## 10.2 Turbine Generator

The information in this section of the reference ABWR DCD, including all subsections, tables and figures, is incorporated by reference with the following departures and supplements.

**Figure 10.2-1 Turbine Stop Valve Closure Characteristic**

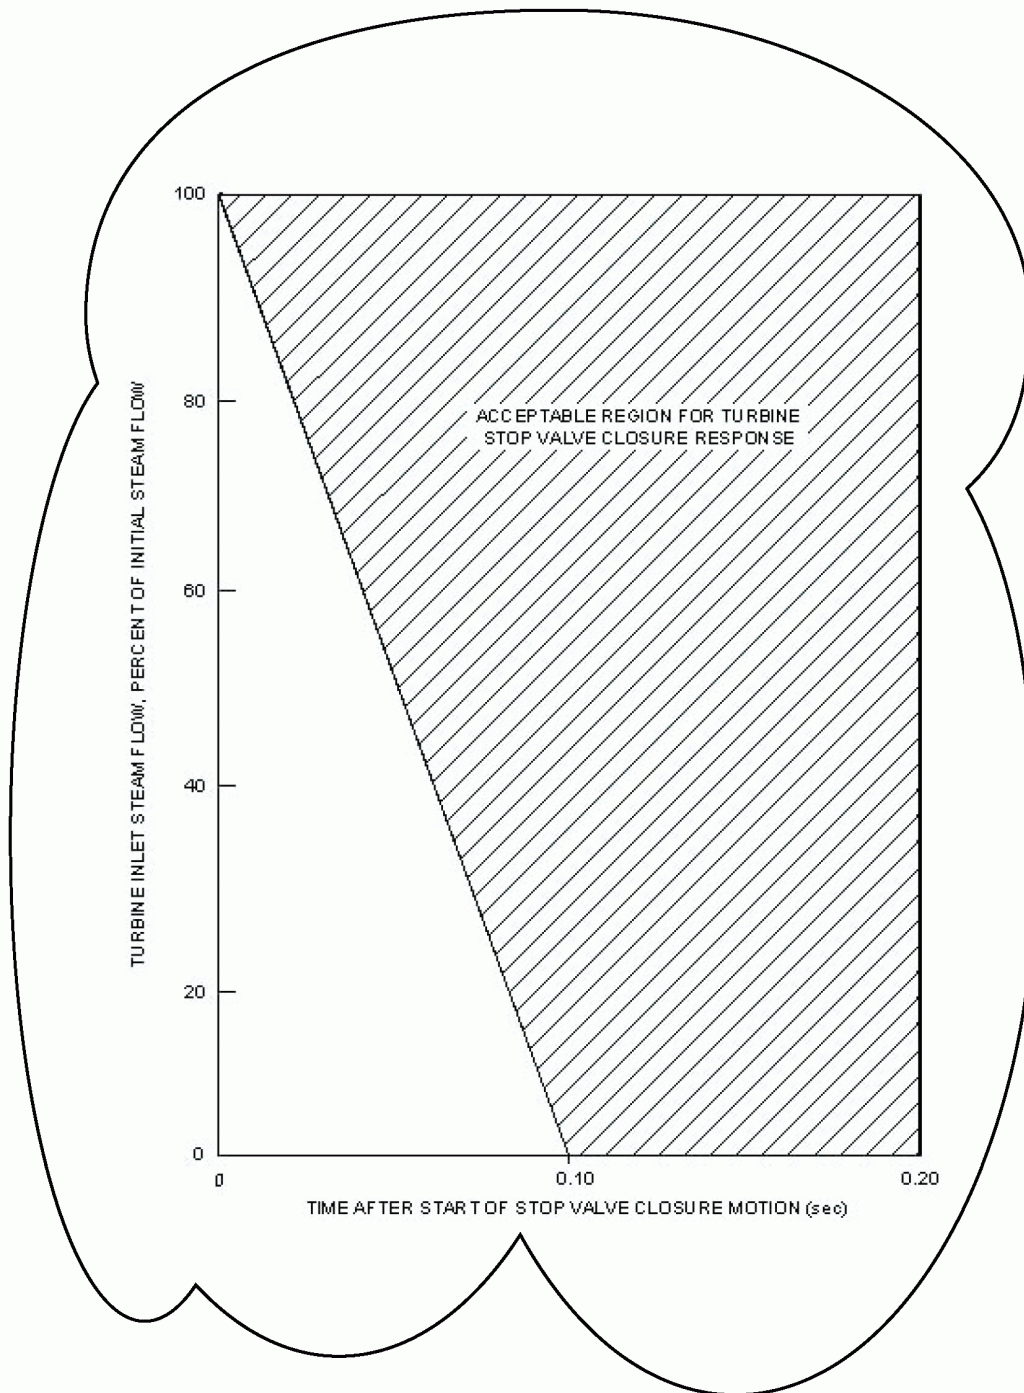
STD DEP Admin (Figure 10.2-1)
